Description of Scenario Leading to Sync Receipt Timeout in 802.1AS Due to Loss of a Single Follow_Up Message

Geoffrey M. Garner
Consultant

IEEE 802.1 TSN TG
2013.05.14

Reproduced from Figure 11-6/802.1AS

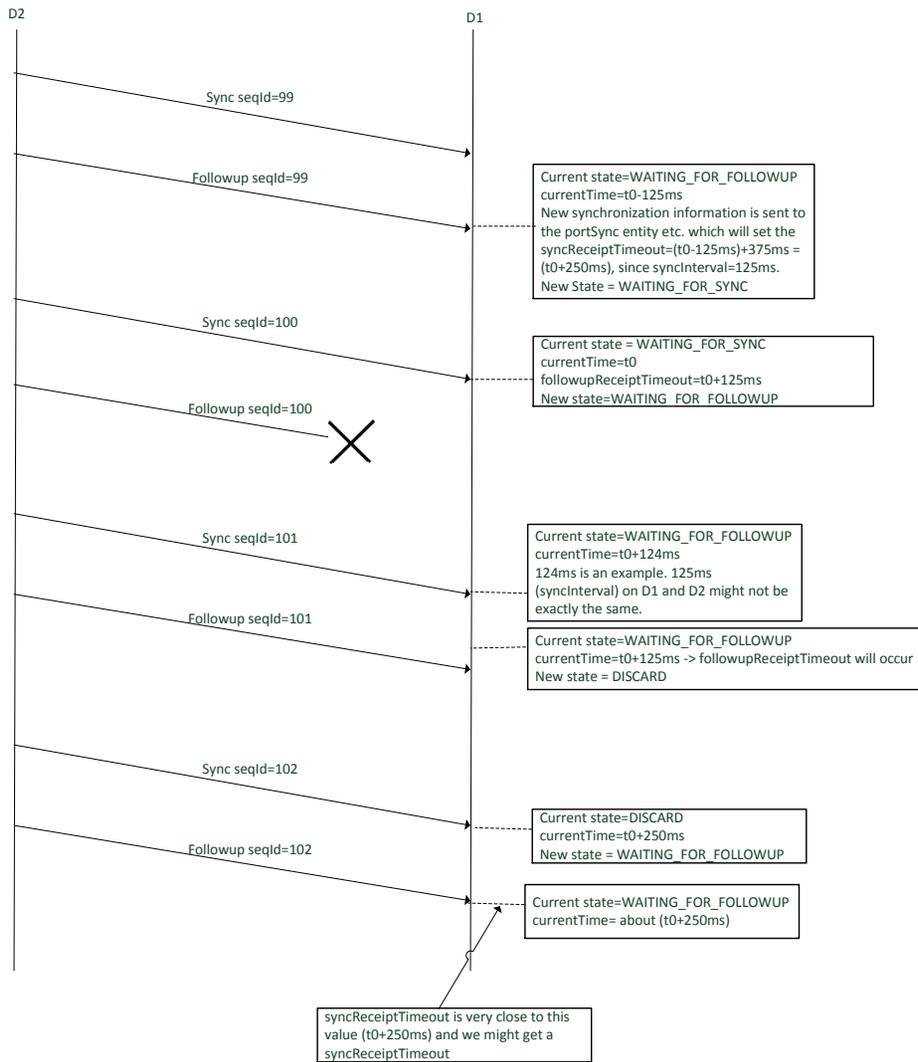
- ❑ Sync interval = 125 ms
- ❑ Sync receipt timeout = 3 sync intervals
- ❑ Sync message 99 arrives; go to state WAITING_FOR_FOLLOWUP
- ❑ Follow_Up message 99 arrives at time t0-125 ms; go to state WAITING_FOR_SYNC
 - Information is sent to PortSync entity, and PortSyncSyncReceiveSM sets syncReceiptTimeoutTime to currentTime+375 ms = t0+250 ms
- ❑ Sync message 100 arrives at time t0 (slightly late since it is more than 125 ms later than previous Sync); go to state WAITING_FOR_FOLLOWUP
 - followUpReceiptTimeoutTime set to t0+125 ms by MDSyncReceiveSM
- ❑ Follow_Up message 100 is lost
- ❑ Sync message 101 arrives at time t0+124 ms, i.e., slightly early
 - It is ignored, because MDSyncReceiveSM is still waiting for Follow_Up

- ❑ At time t_0+125 ms, followUpReceiptTimeout occurs; go to state DISCARD
- ❑ Follow_Up message 101 arrives, and is ignored because Sync message 101 was not processed
- ❑ Sync message 102 arrives at time t_0+250 ms; go to state WAITING_FOR_FOLLOWUP
 - followUpReceiptTimeoutTime set to t_0+375 ms by MDSyncReceiveSM
- ❑ Follow_Up message 102 will arrive between t_0+250 ms and t_0+375 ms
 - However, syncReceiptTimeoutTime is set to t_0+250 ms
- ❑ Therefore, sync receipt timeout occurs at time t_0+250 ms
 - Sync receipt timeout has occurred, even though only one Follow_Up message has been lost

- a) After initial Follow_Up message was lost, the MDSyncReceiveSM continued to wait for the Follow_Up, for the remainder of the interval until followUpReceiptTimeoutTime
- b) Since the Follow_Up receipt timeout interval is equal to the Sync interval, this meant that the state machine waited until the next Sync interval
- c) Unfortunately, the next Sync arrived slightly early; it was ignored because the state machine does not process the next Sync until it is finished processing the current Sync (or has declared the current Sync or Follow_Up lost)
 - It was decided early in the development of 802.1AS not to require processing of multiple outstanding Follow_Up messages (for multiple Sync messages), to avoid complexity; this behavior is desired

Possible Fix - 2

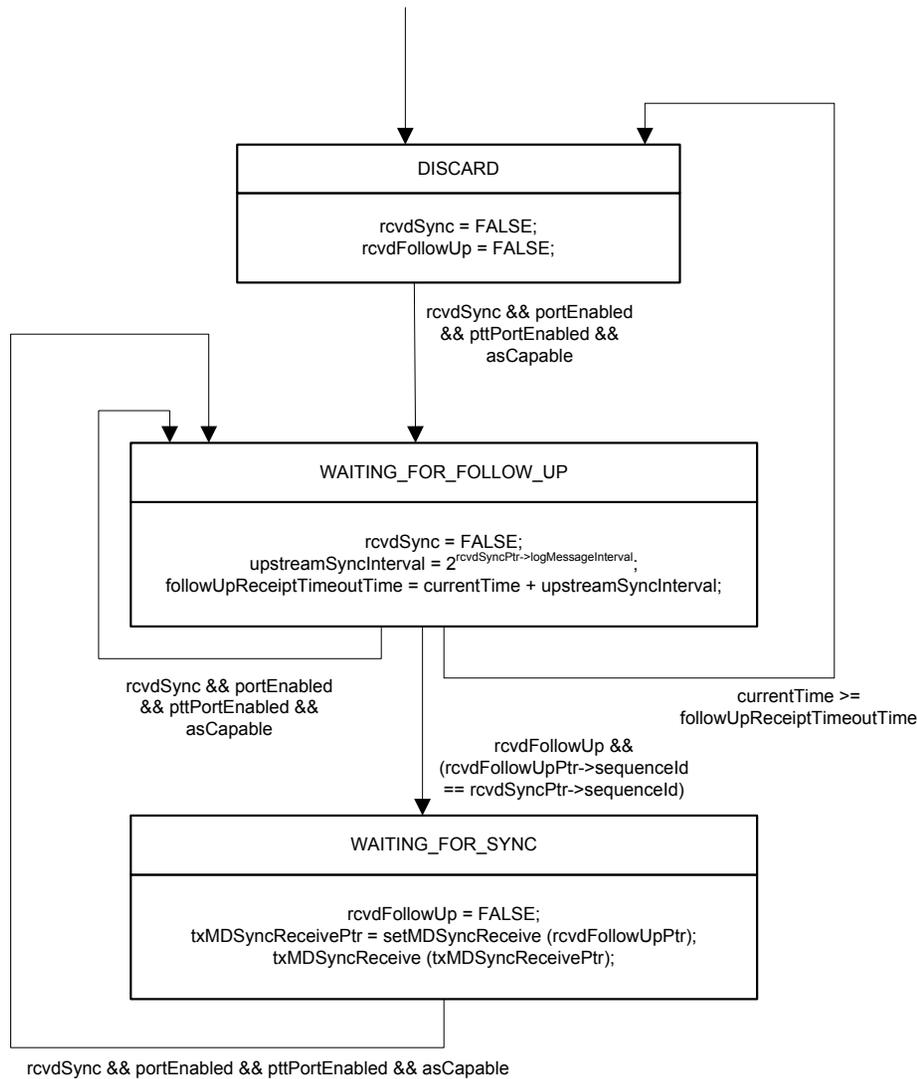
- It was suggested in the June 19, 2013 TSN call that a simple fix would be to declare a Follow_Up message lost if it has not arrived by the time the next Sync message arrives
- This is reasonable, because a sender sends Follow_Up corresponding to the most recent Sync message it has sent before sending the next Sync message
 - This is implied by the MDSyncSendSM state machine (see Figure 11-7/802.1AS-2011)
 - The order of the frames will not change on the link between the sender and receiver, which means that Follow_Up corresponding to a Sync message should arrive before the next Sync message
- This fix can easily be incorporated
 - See next slide for the revised MDSyncReceiveSM State Machine

- ❑ Add a branch out of the WAITING_FOR_FOLLOW_UP state back to itself, with the condition `rcvdSync && portEnabled && pttPortEnabled && asCapable`
- ❑ If a new Sync message is received before either Follow_Up for the current Sync is received or followUpReceiptTimeoutTime is reached, the WAITING_FOR_FOLLOW_UP state is reentered and the followUpReceiptTimeoutTime is reset
